CITY OF ALBUQUERQUE

**RE: Starbucks
1314 Gibson Blvd. SE
Revised Grading and Drainage Plan
Engineer's Stamp Date: 02/17/20
Hydrology File: L15D041**

STARBUCK DRIVE-THRU

GRADING & DRAINAGE PLAN

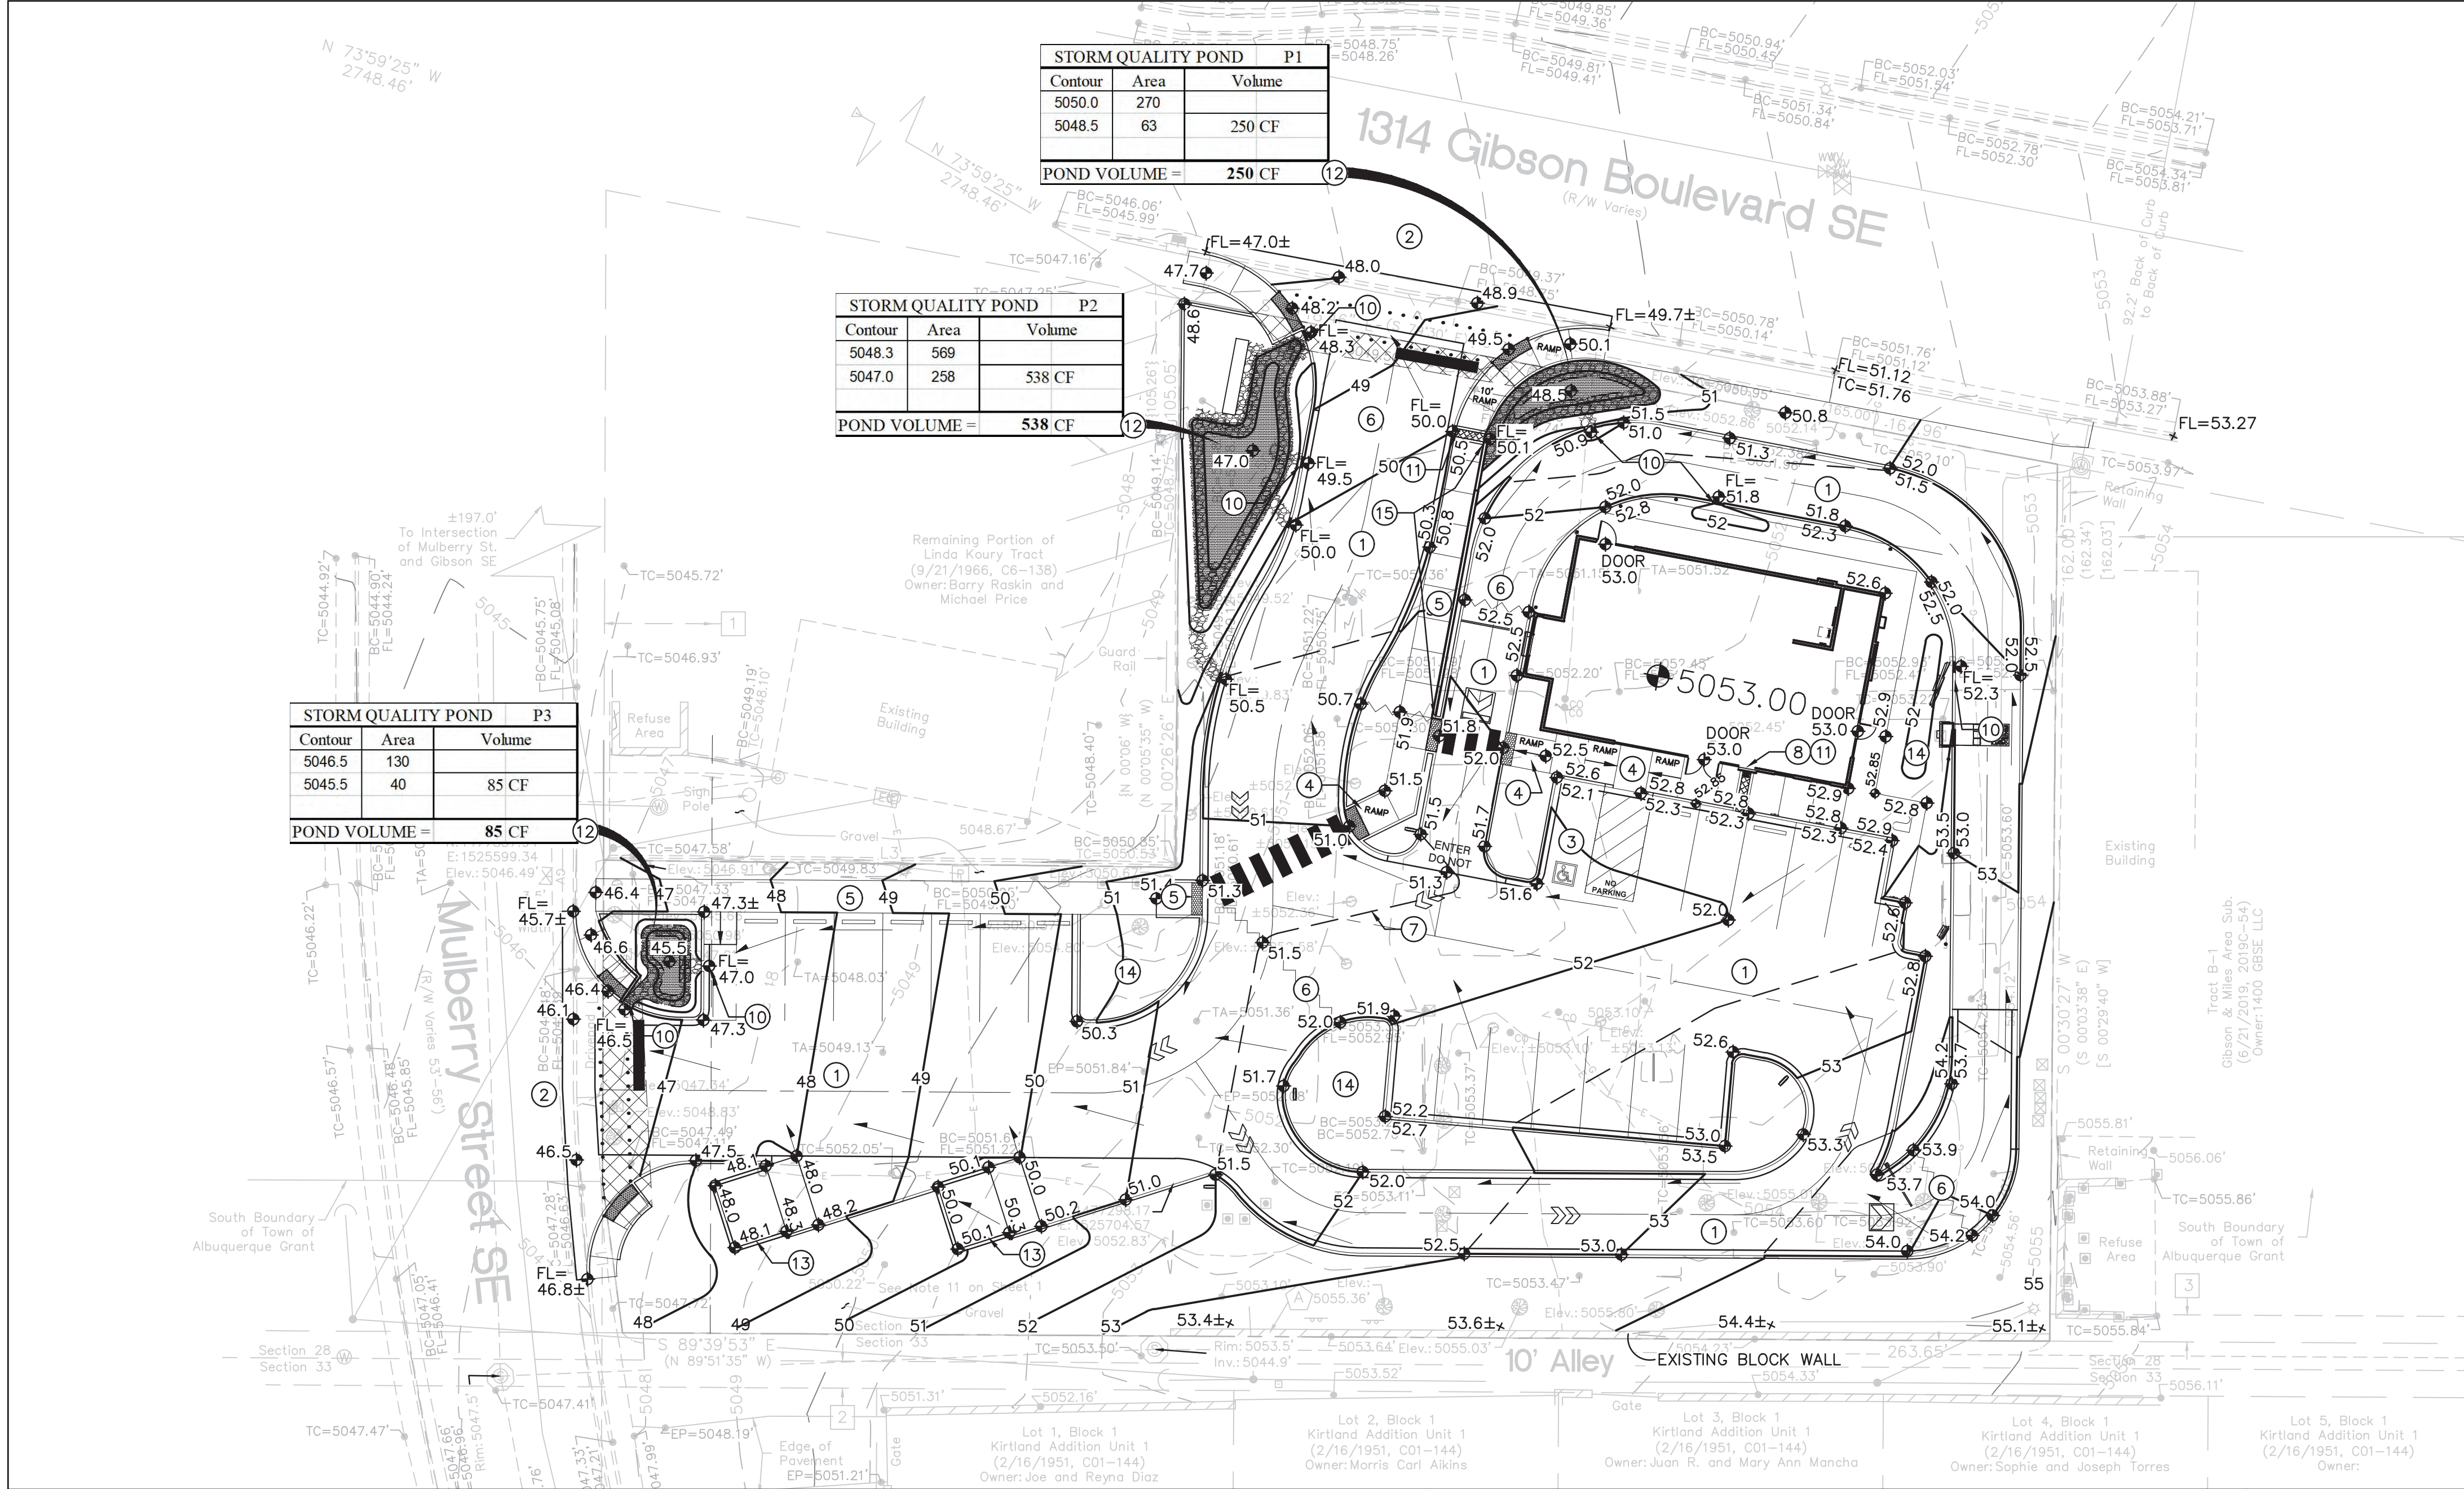
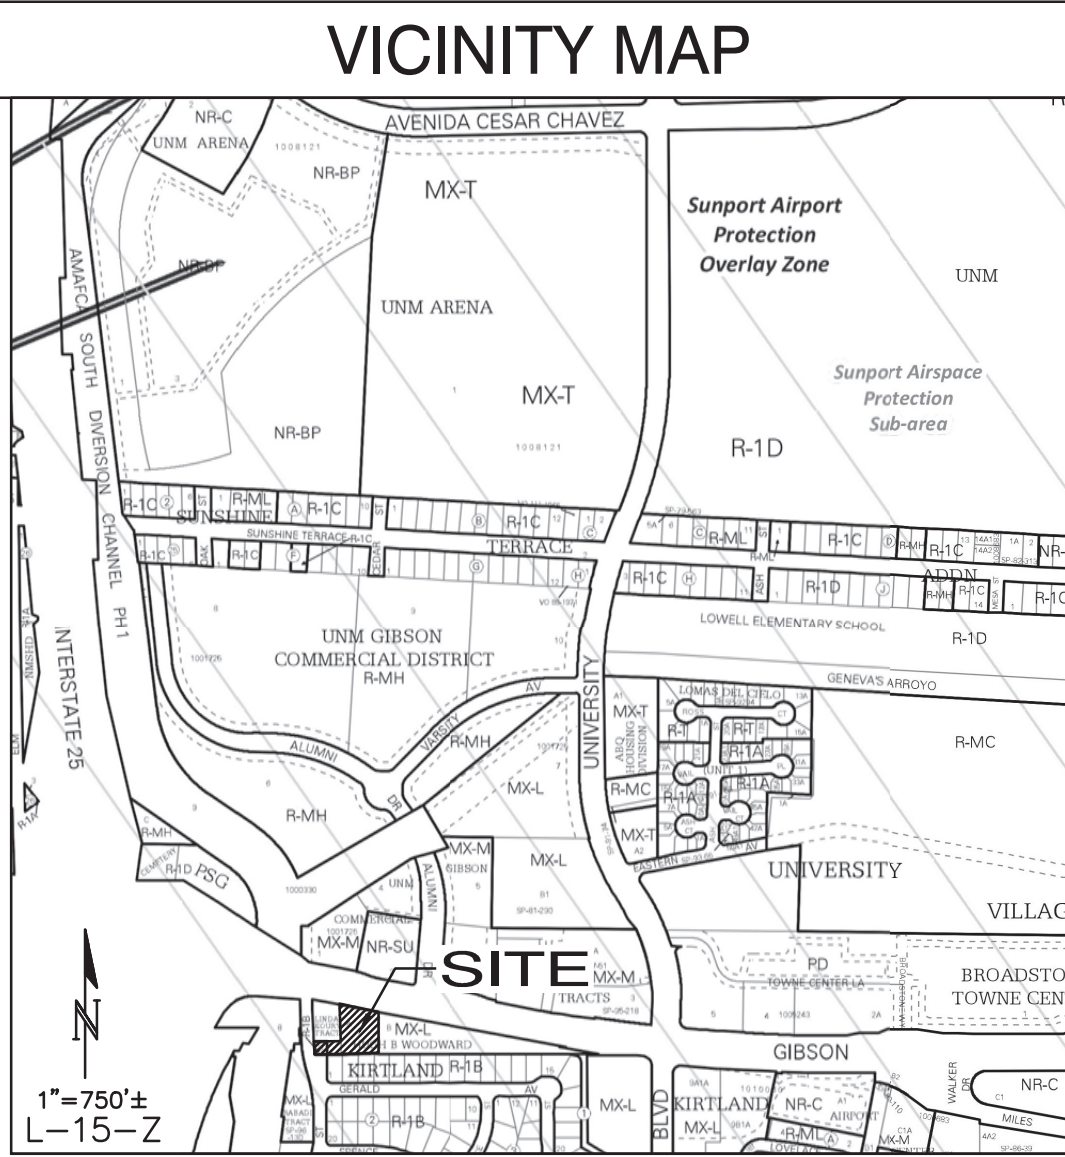
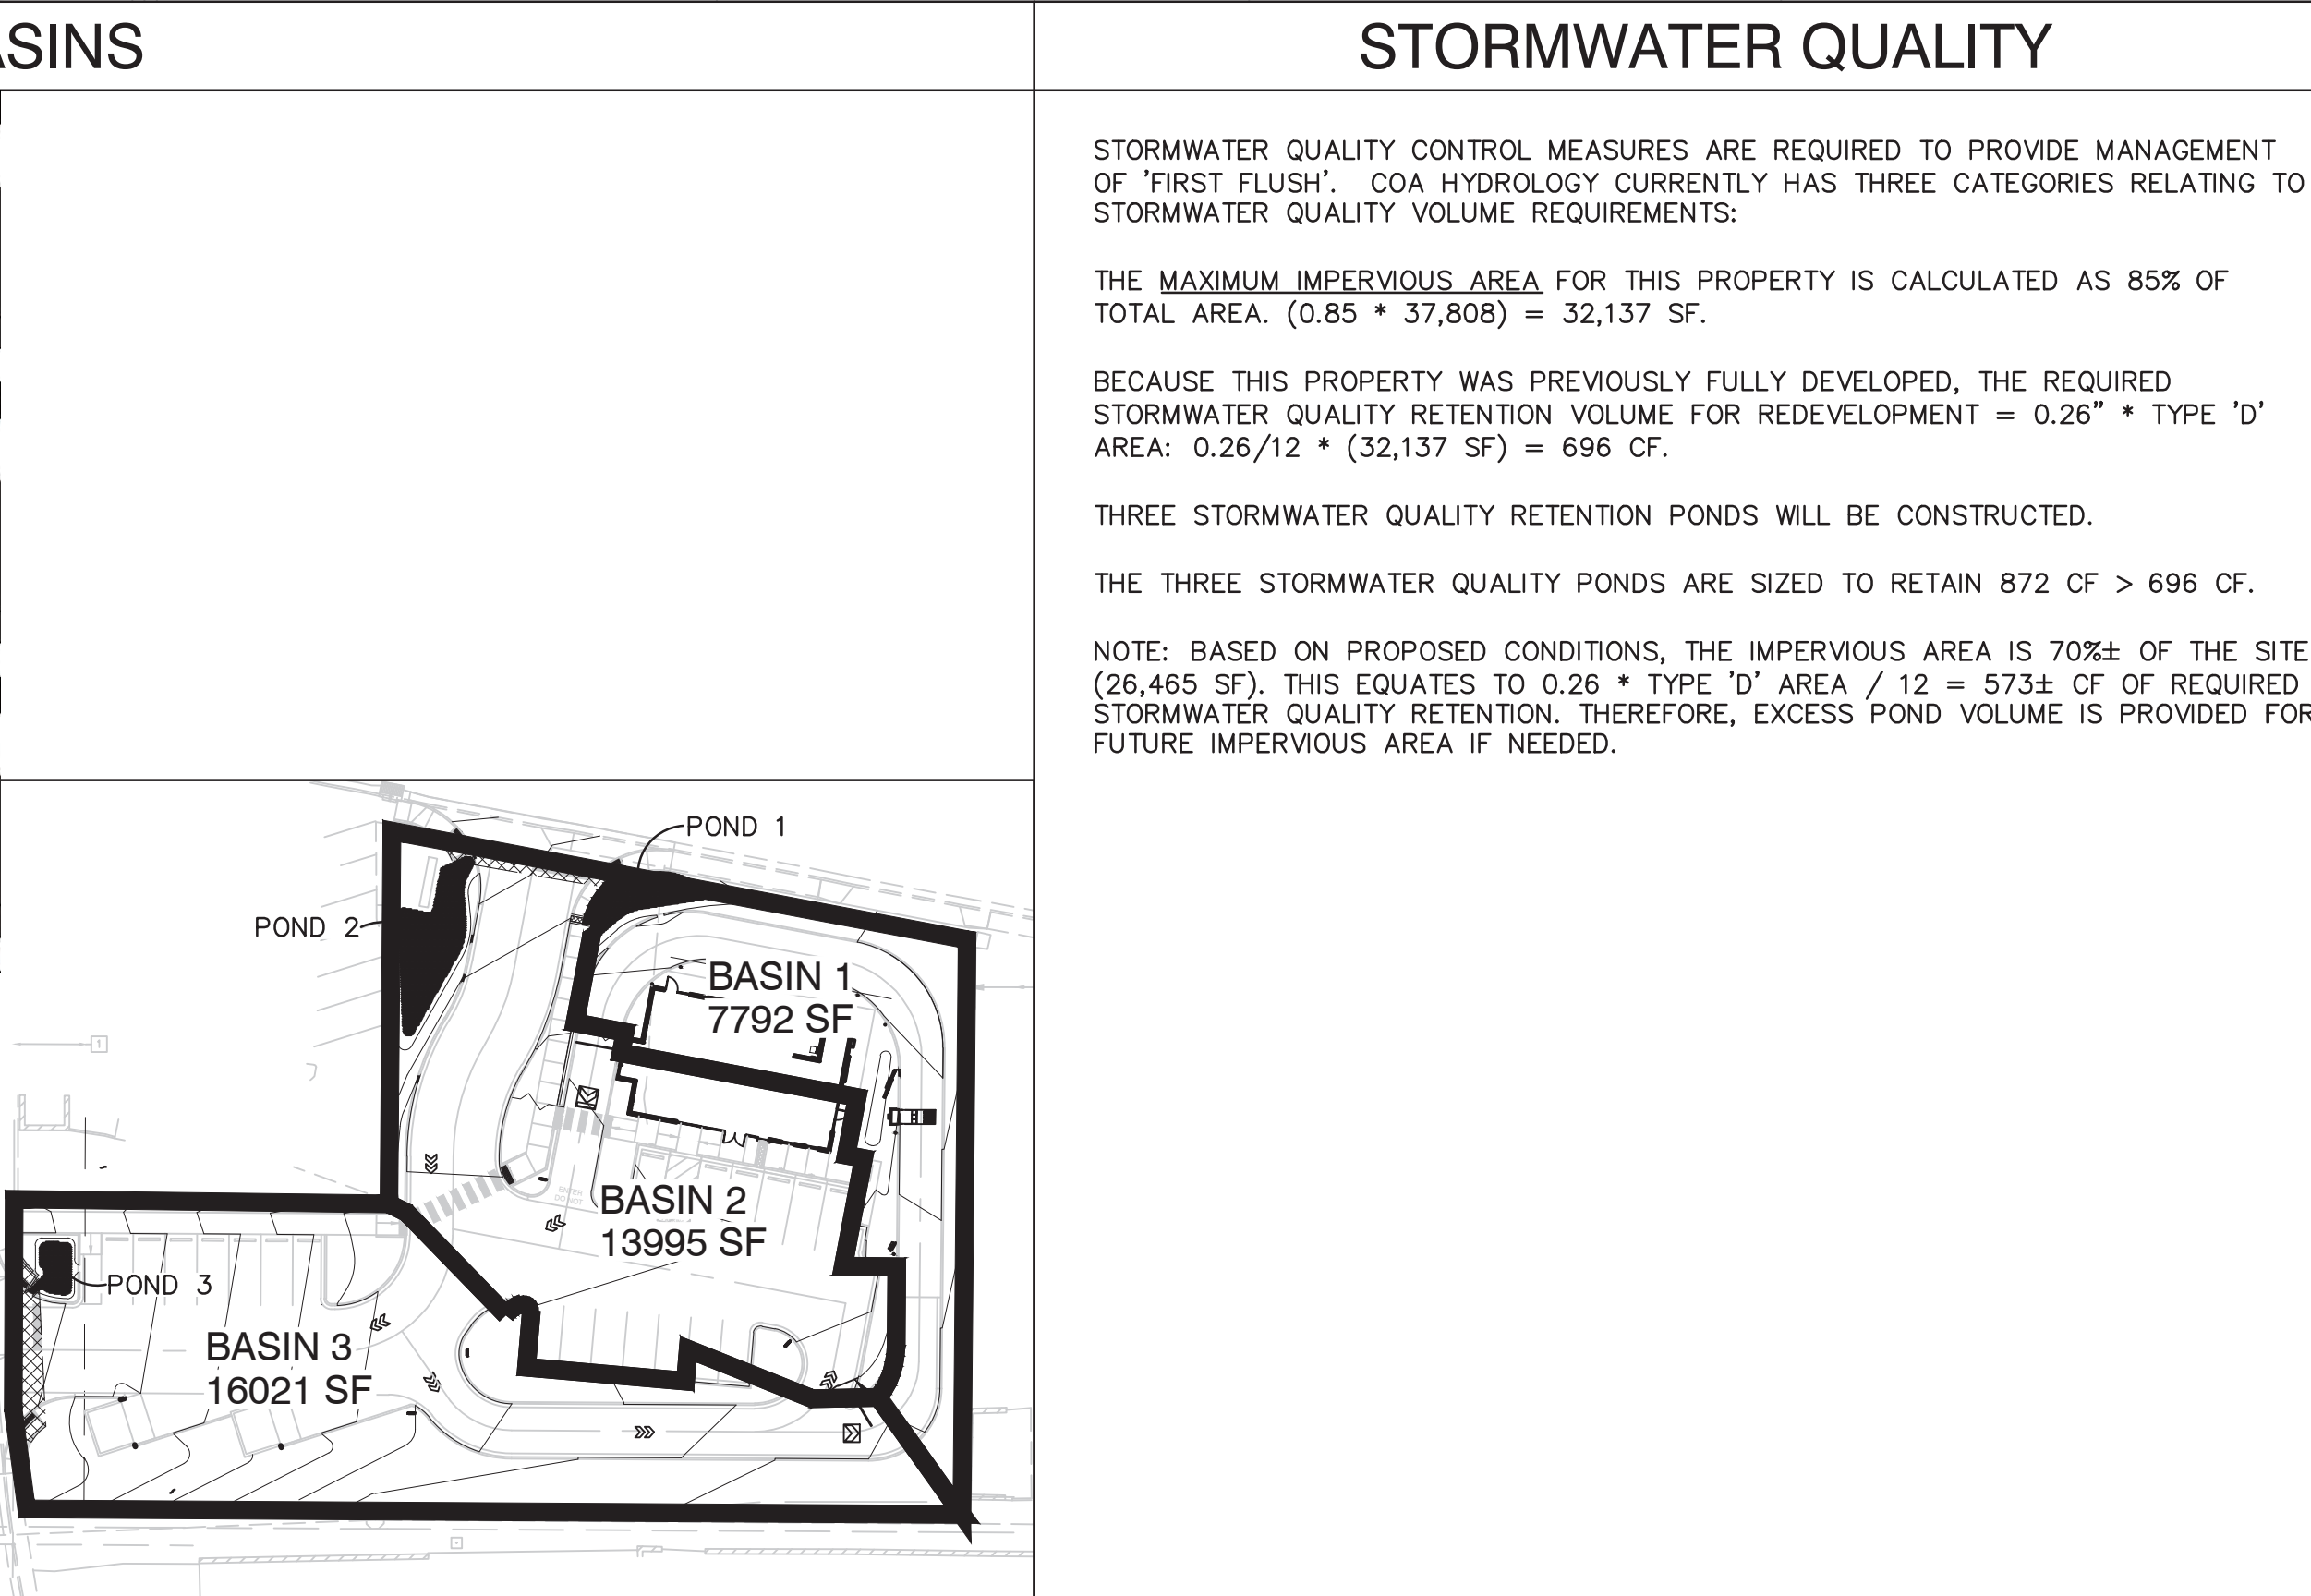
Based upon the information provided in your submittal received 02/18/2020, the Revised Grading and Drainage Plan is approved for Building Permit.

Please attach a copy of this approved plan in the construction sets for Building Permit processing along with a copy of this letter. Prior to approval in support of Permanent Release of Occupancy by Hydrology, Engineer Certification per the DPM checklist will be required.

Also as a reminder, please provide a Drainage Covenant for the proposed stormwater quality ponds per Chapter 17 of the DPM prior to Permanent Release of Occupancy. Please submit this on the 4th floor of Plaza de Sol. A \$25 fee will be required.
